Portage County, Atwater Twp.

Kelly #1 SWD Permit #

SWIN # 44

SWIW Permit Conditions

PORTAGE CO. ATWATER TWP.

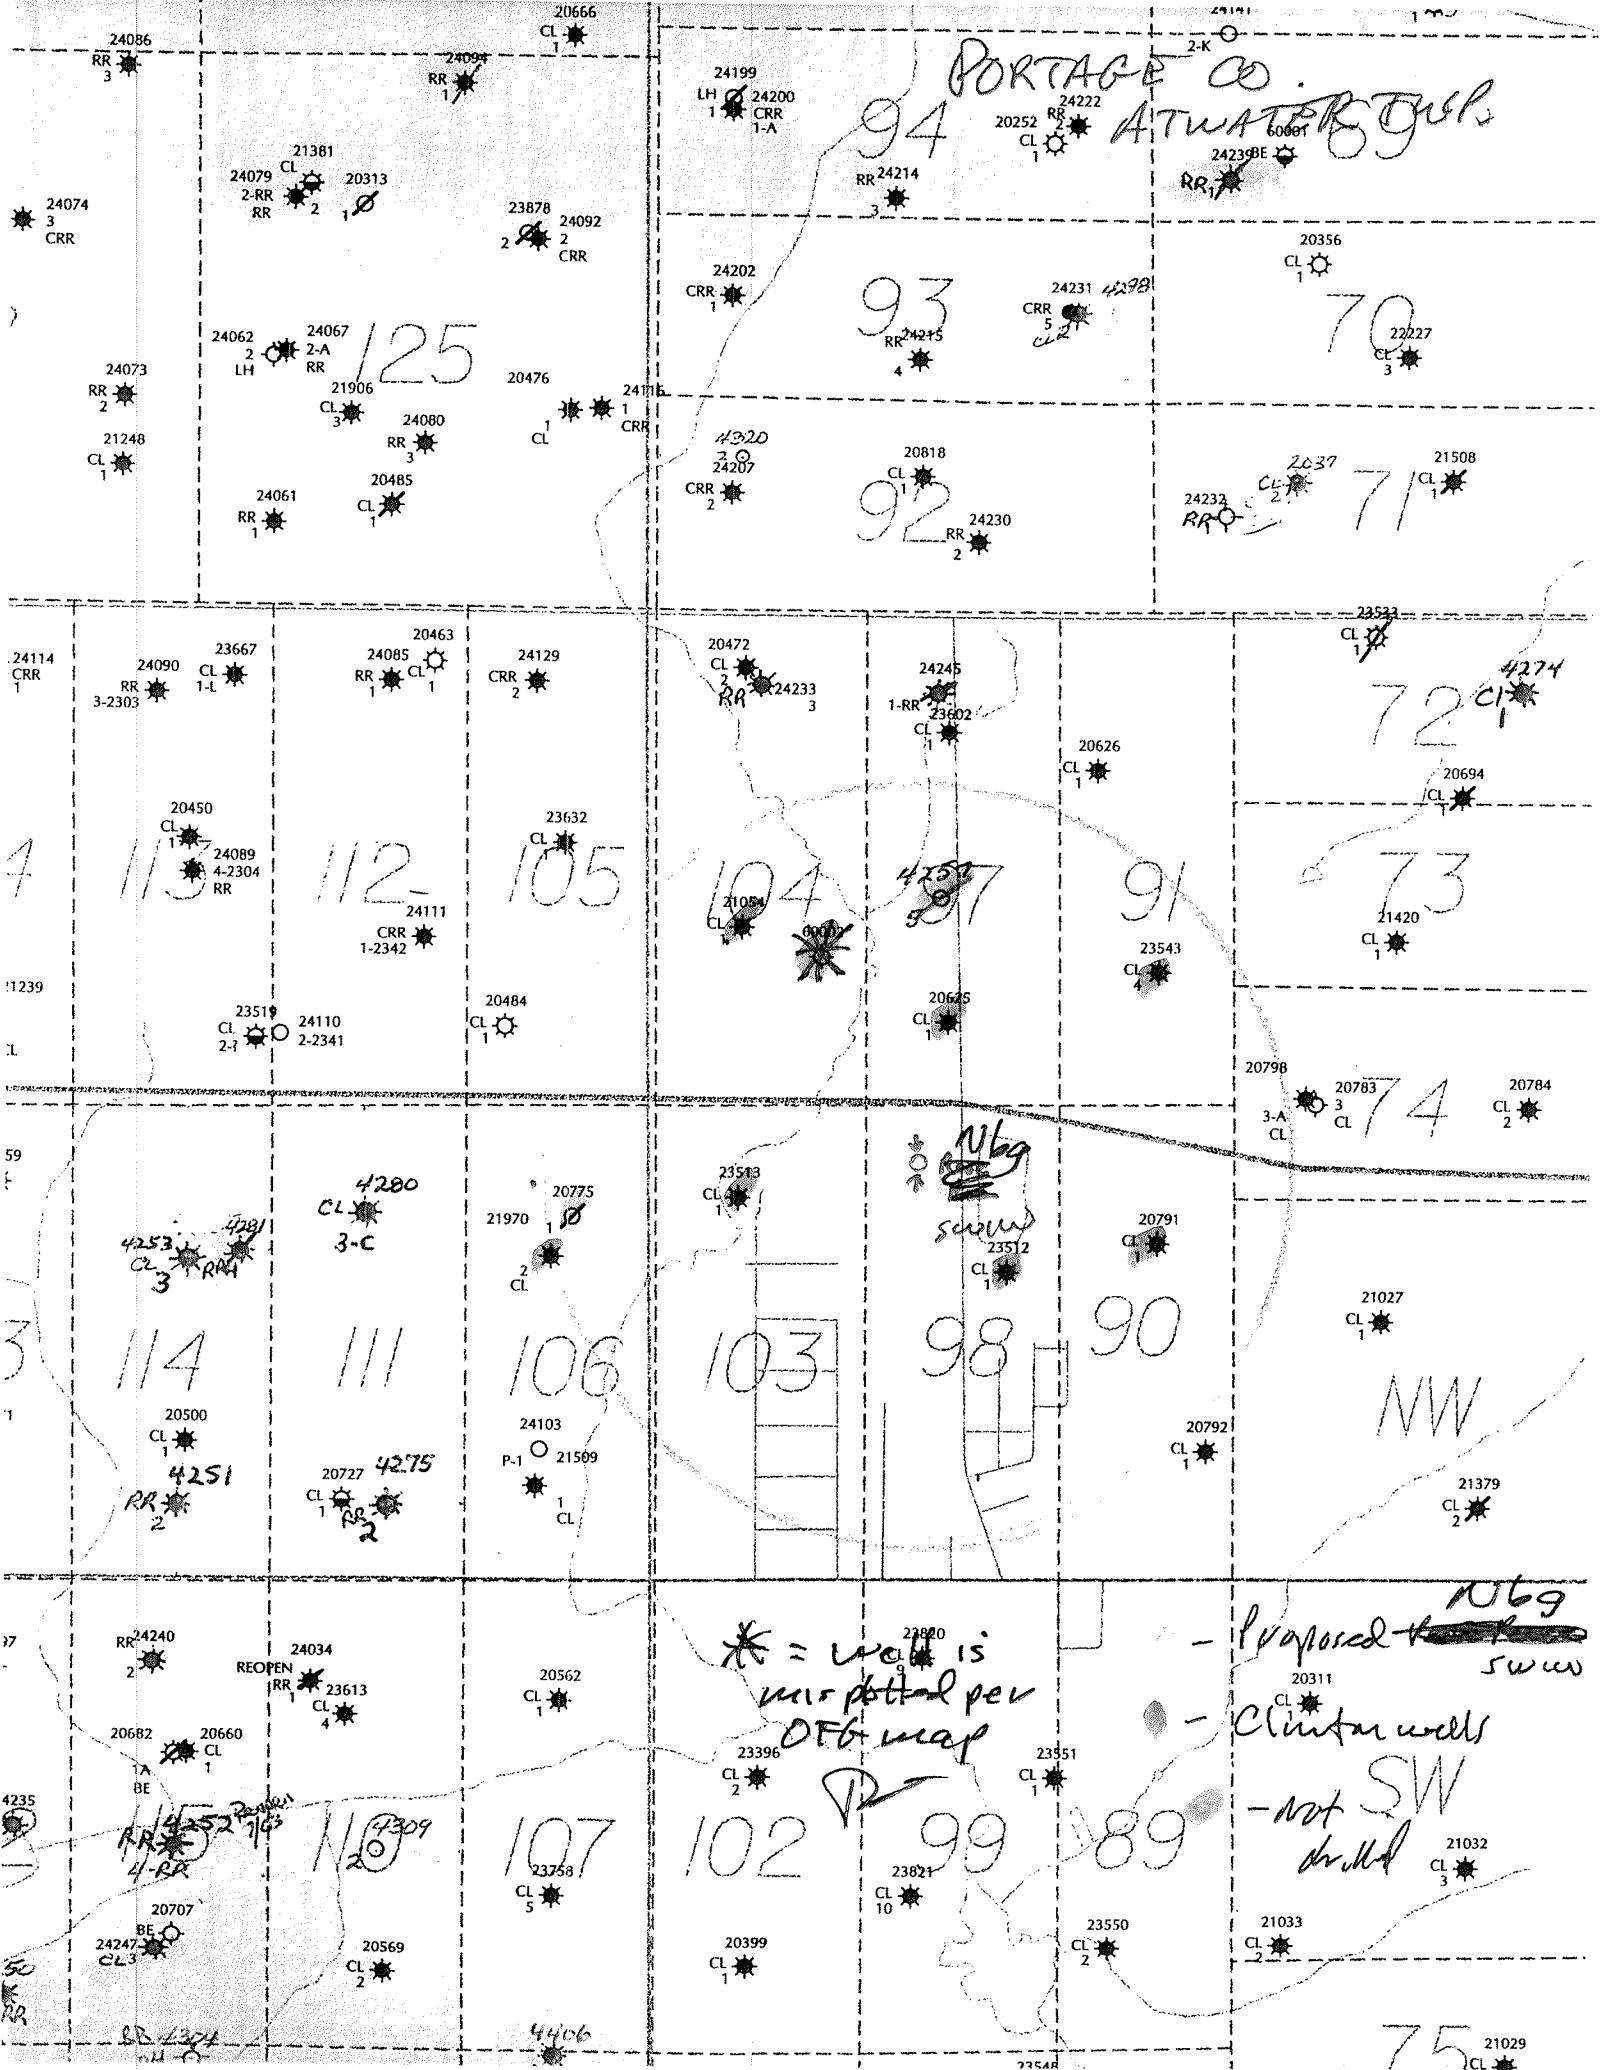
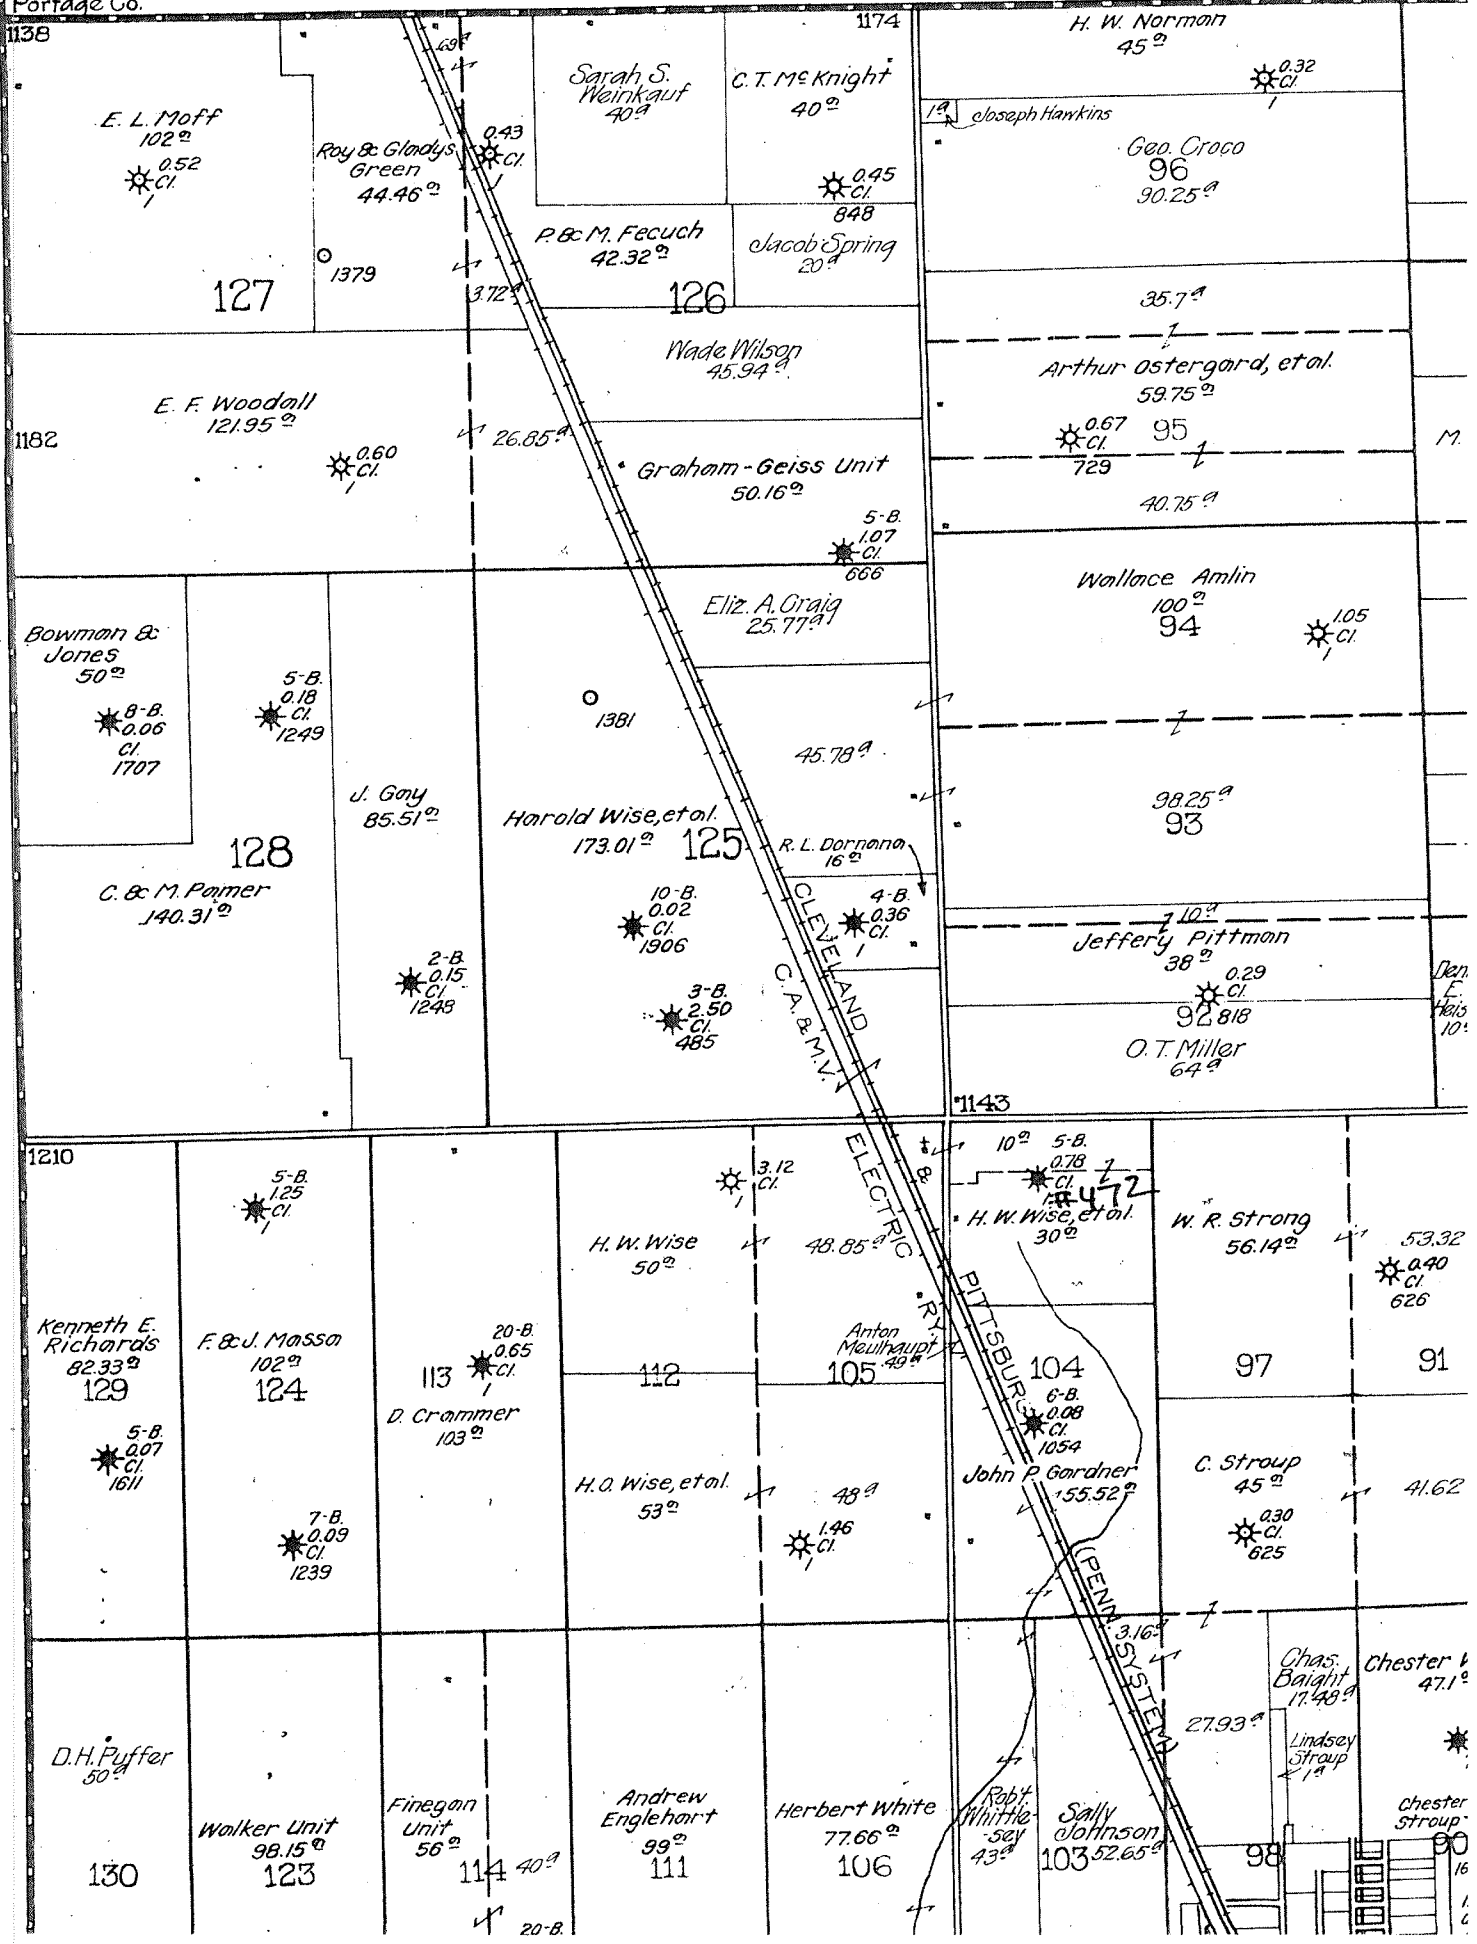
NOTE: Proposed injection well should be circumscribed with appropriate radius and all wells clearly labeled and identified. A legend depicting color code is requires.

* = well is
mis plotted per
DfG map
